PROPOSED DEVELOPMENT
ST. GEORGES HOTEL,
WESTCLIFF GARDENS,
BOURNEMOUTH,
DORSET, BH2 5HL

PROPOSED FLOOR PLANS
(3 OF 3)

PROPOSED FLOOR PLANS
(2 OF 3)

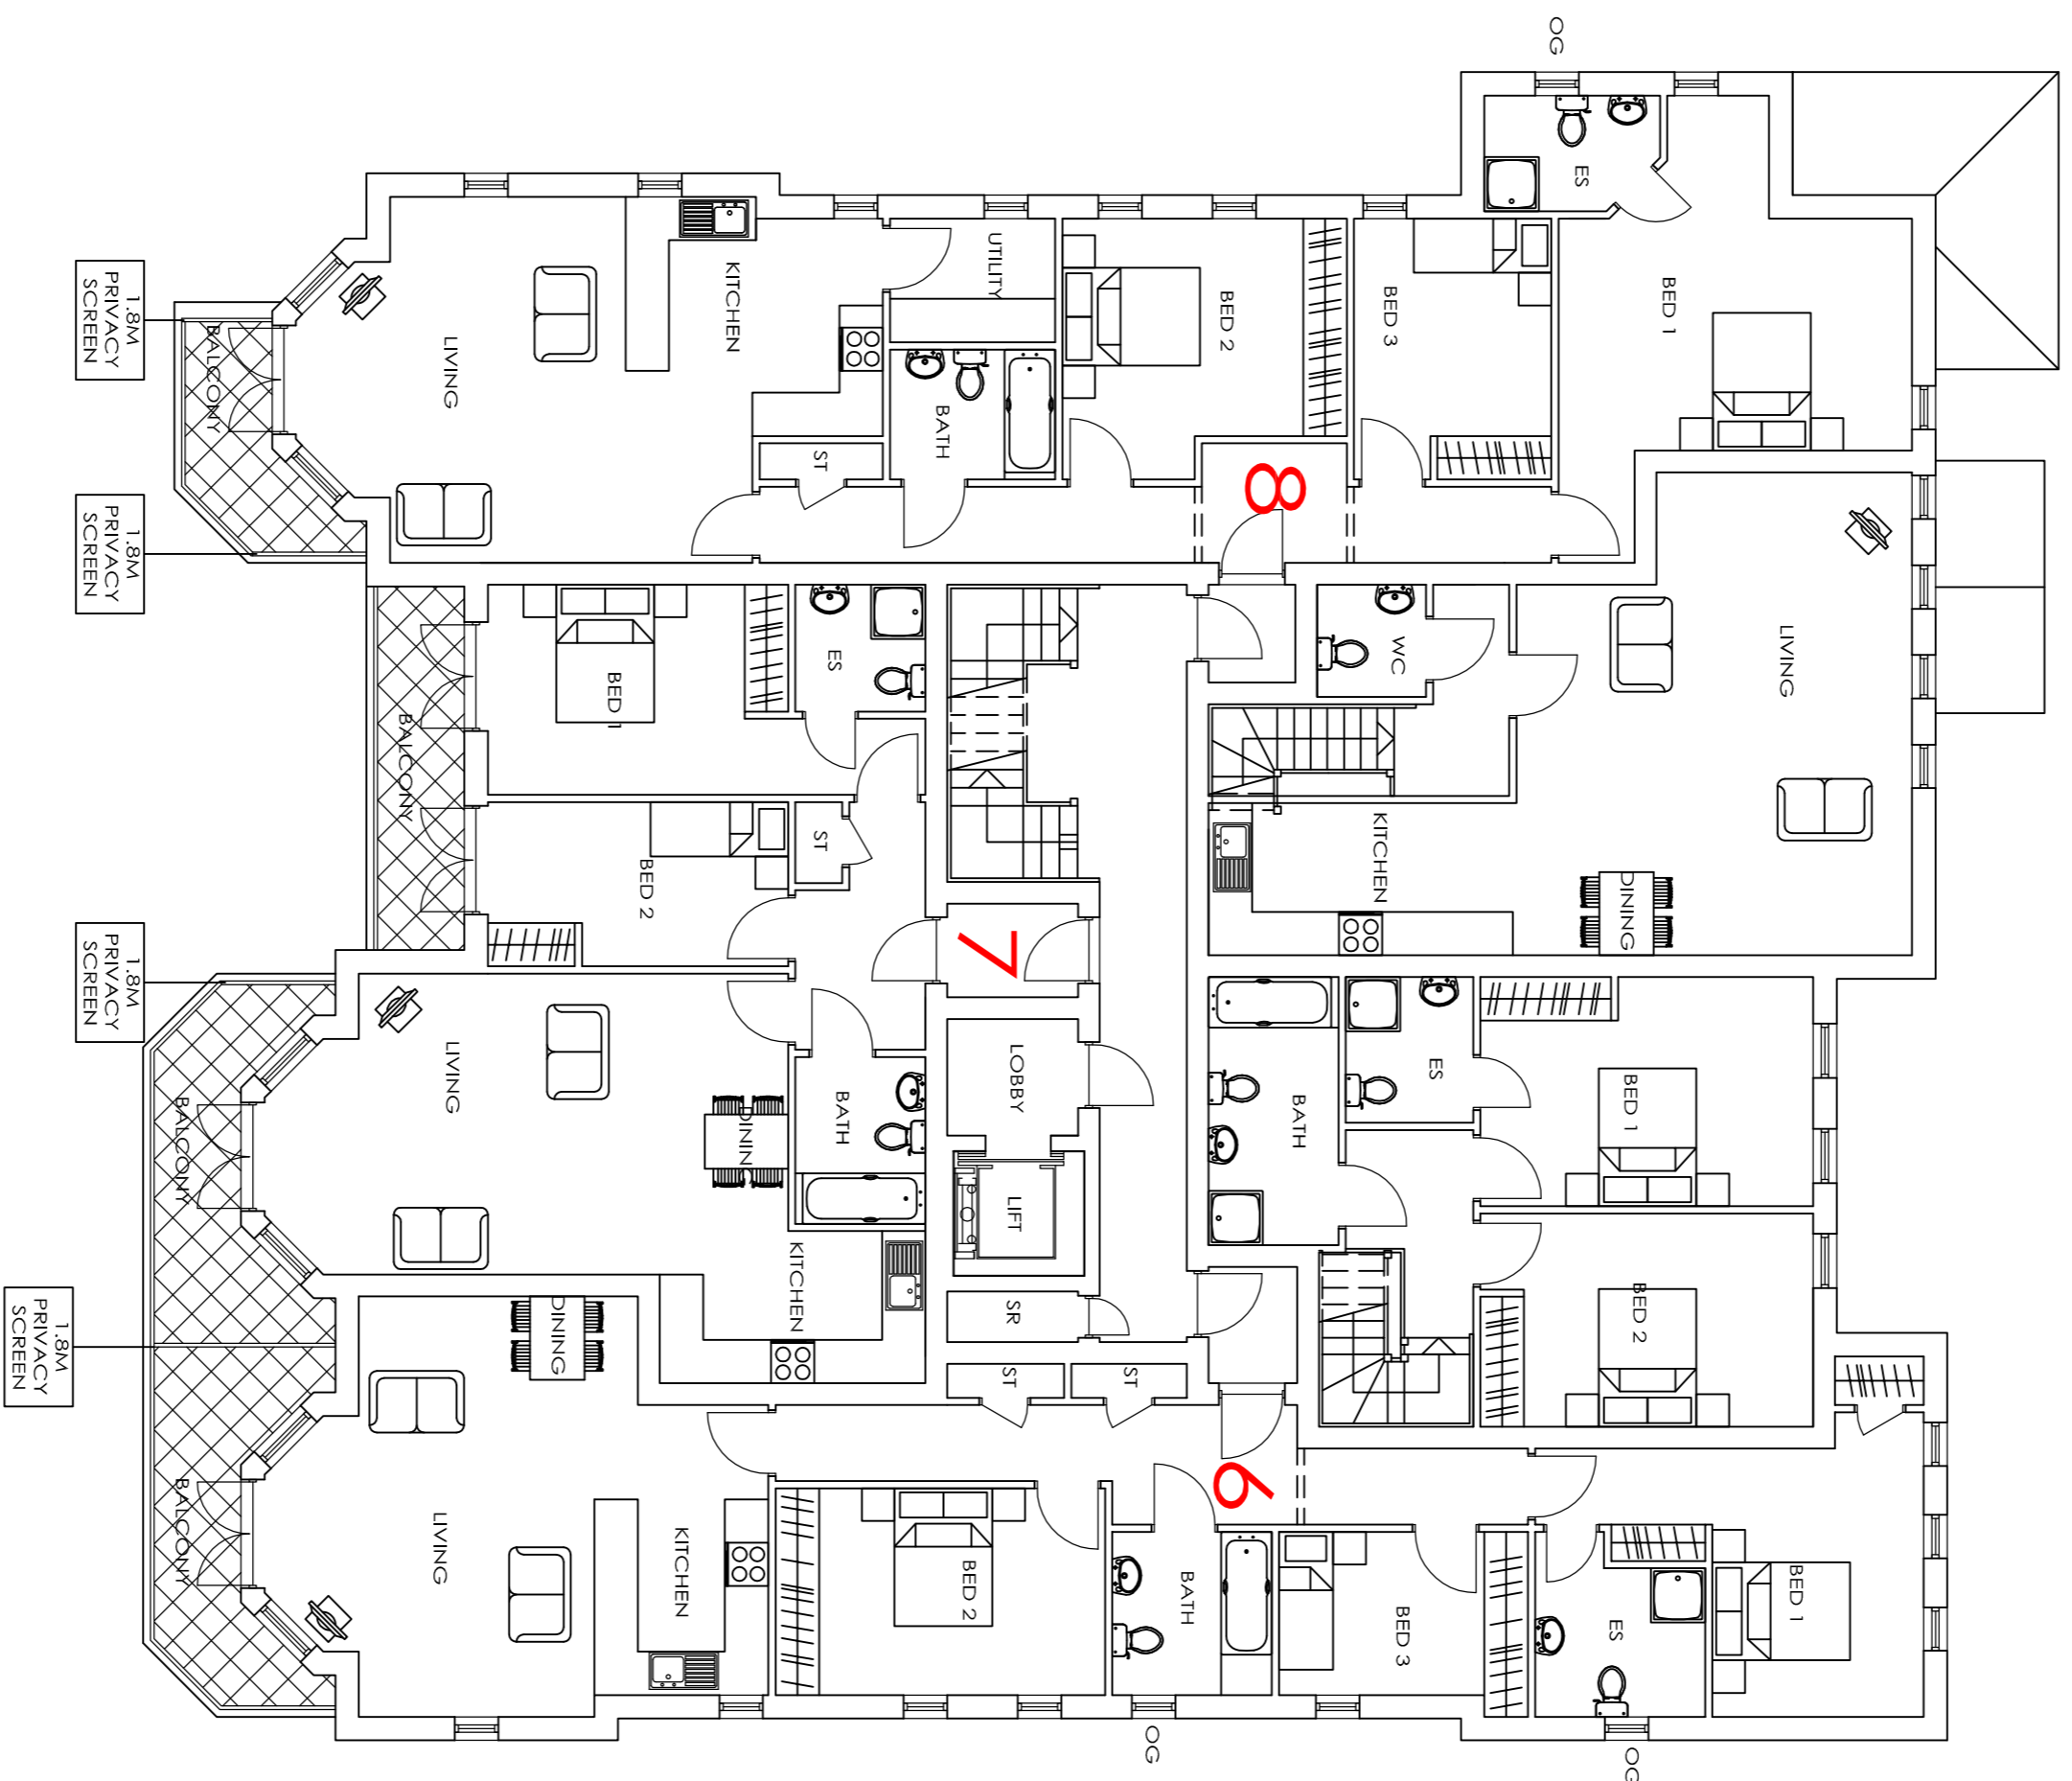
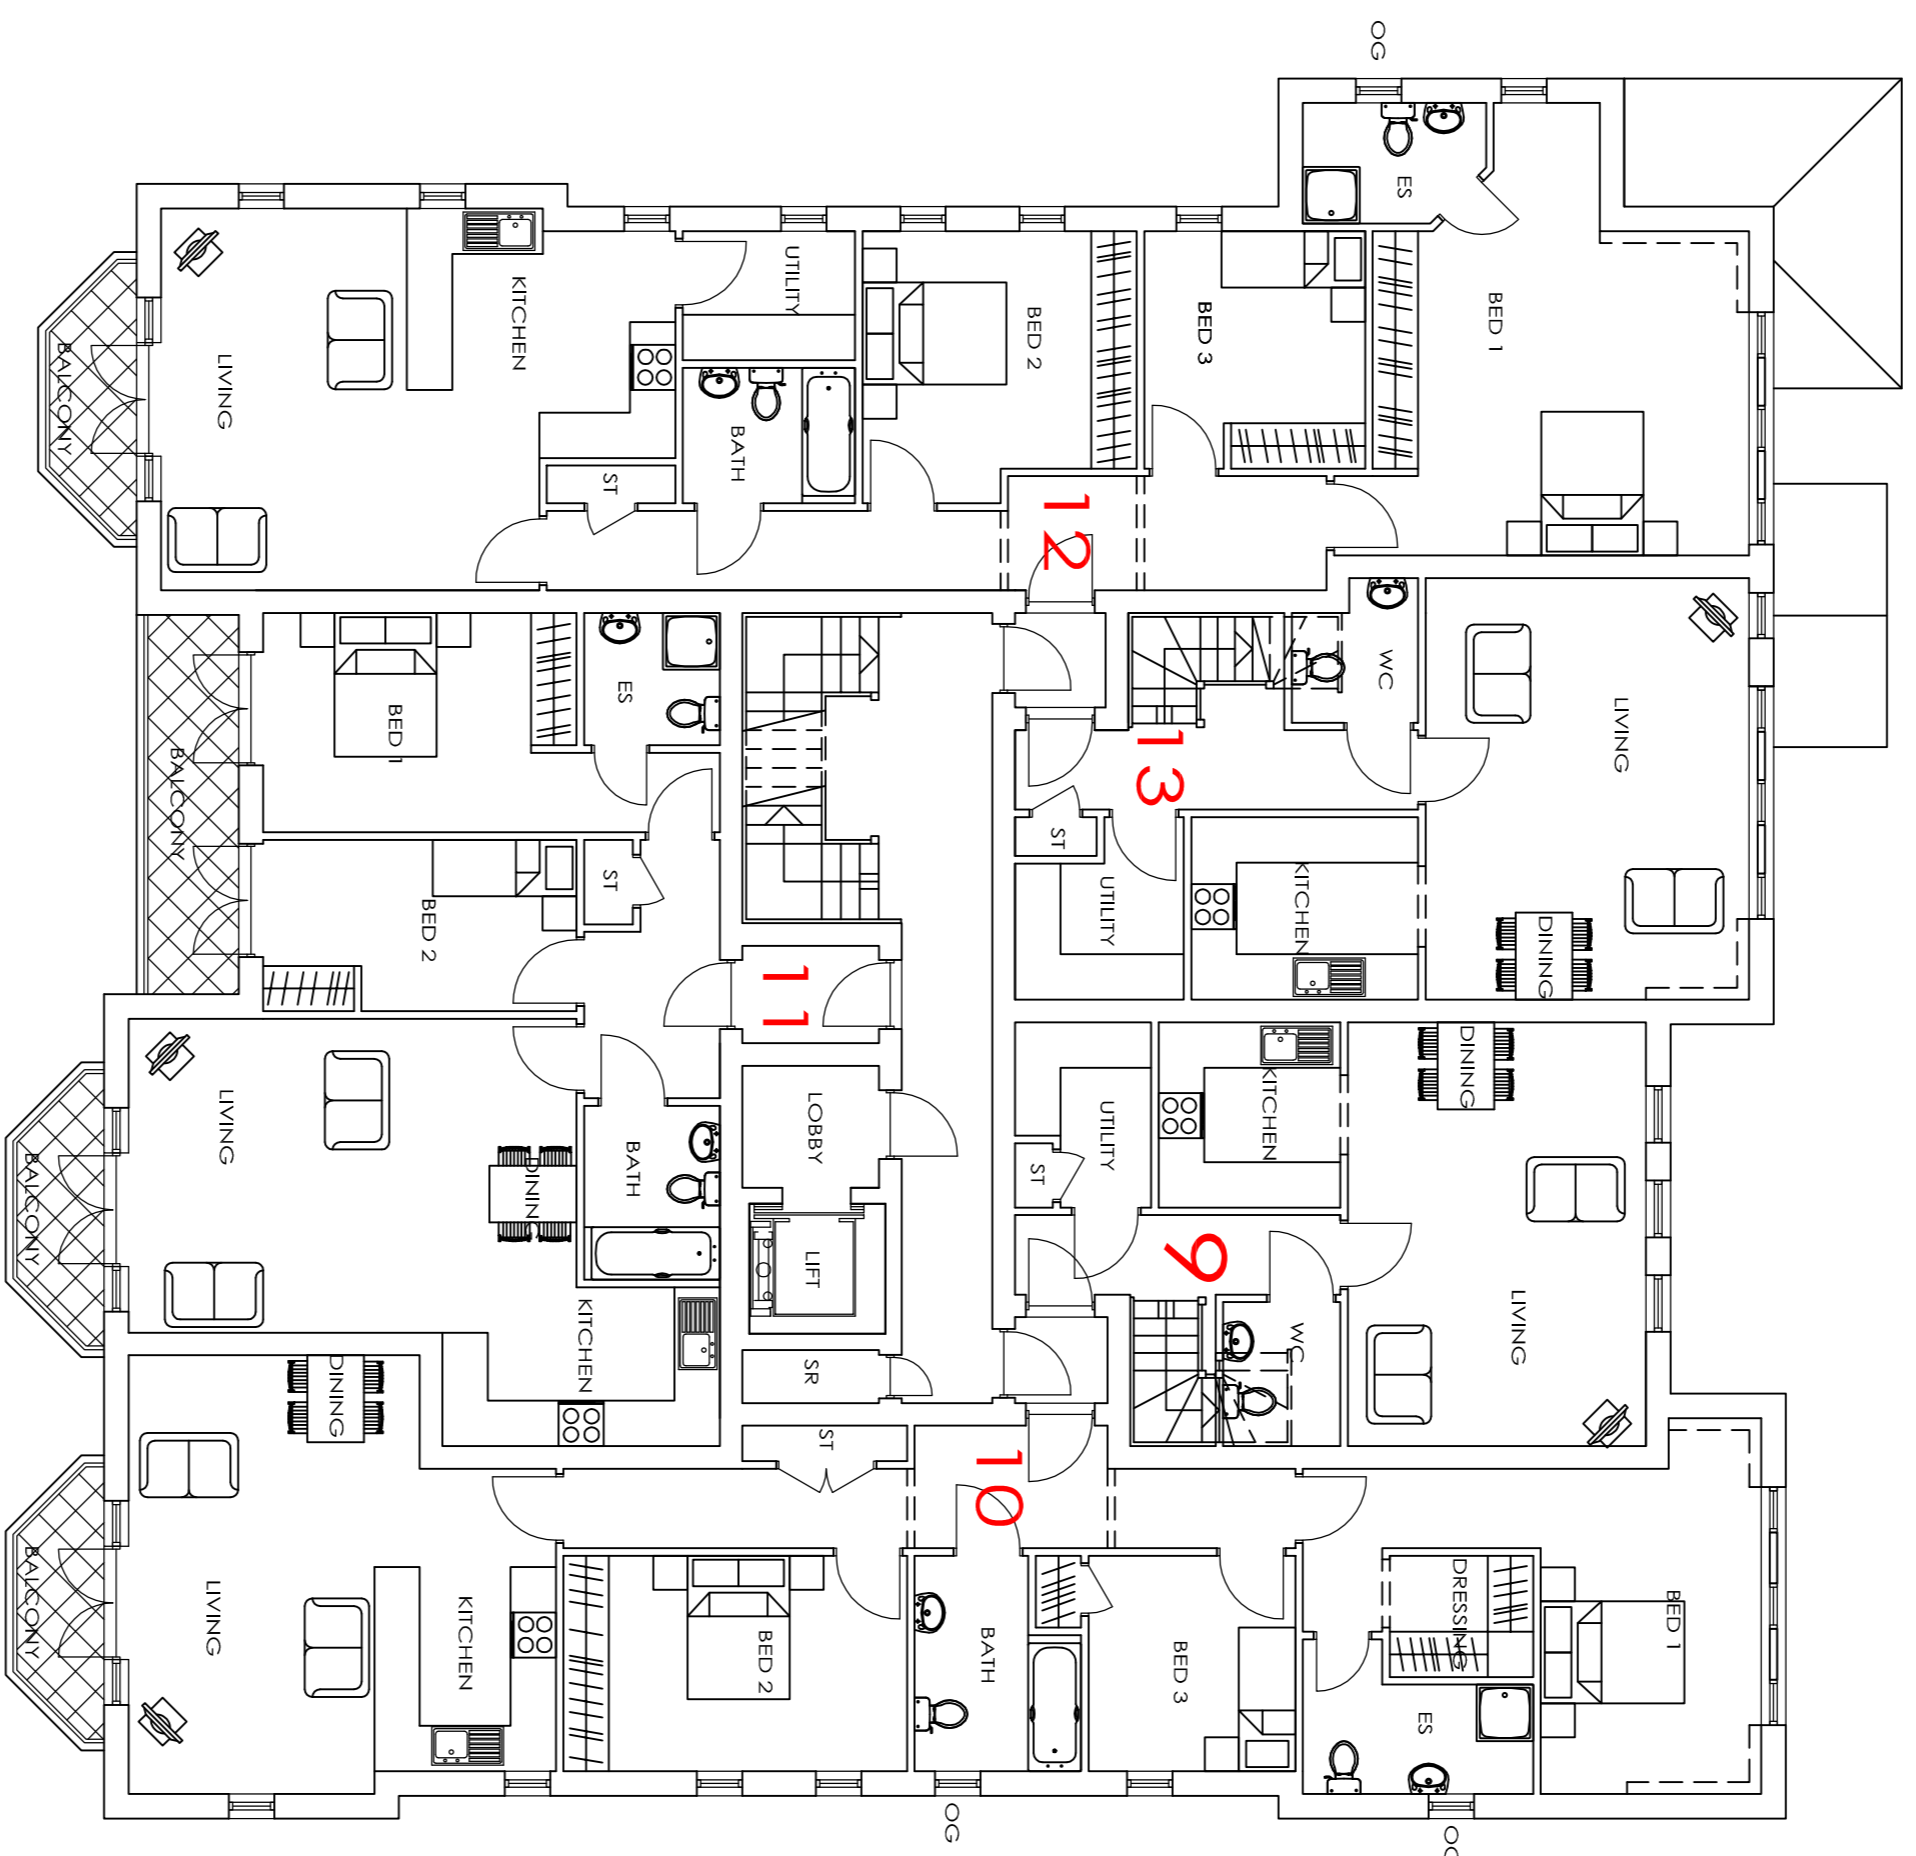
- A PLANNERS COMMENTS: 25-10-11 LM
- MOVED MAIN ENTRANCE
 - FLAT 8 BALCONY REDUCED
 - AMENDMENT TO MATERIAL SCHEDULE
